SERVICE BULLETIN

SUBJECT: NIGHT RIDER and FREEDOM MEMORY CHIP COMBINATIONS

You may have noticed a new look on two of the printed circuit boards used in POWER PLAY. The basic change is to single sided printed circuit boards on the Display Driver Module and the Solenoid Driver/Voltage Regulator Module. The new boards also carry a new part number:

THE FOLLOWING IS A LIST OF CORRECTIONS TO BE MADE ON ALL EIGHT BALL SCHEMATICS:

CONVERSION TO ELECTRONIC CHIMES

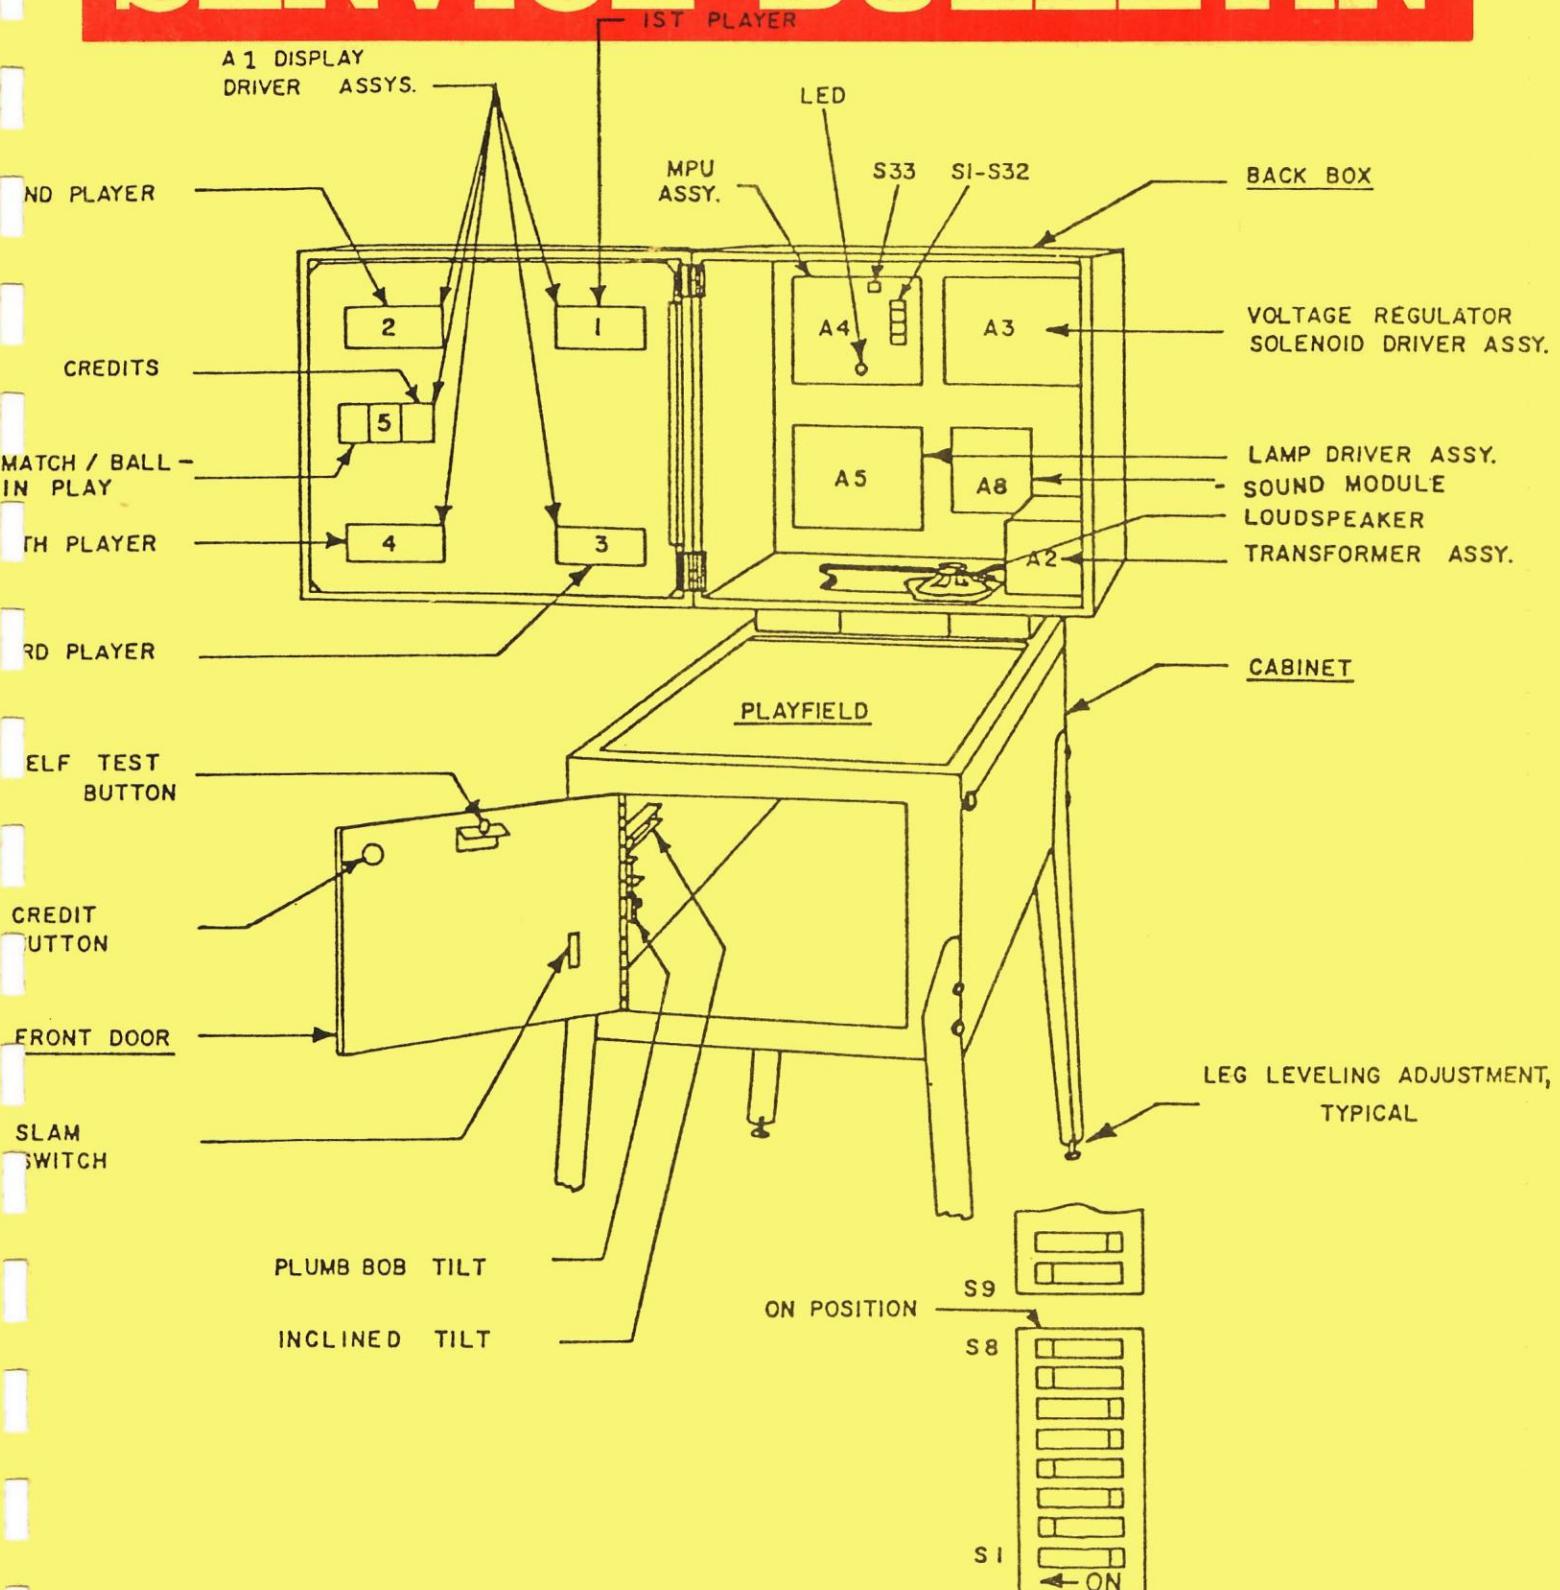
Step 2: Mount brackets, P-6442-213, to back box under Solenoid Driver using P.C.B. as a guide. (See Fig. 1).

Step 3: Mount speaker to cabinet as shown in Fig. 1.
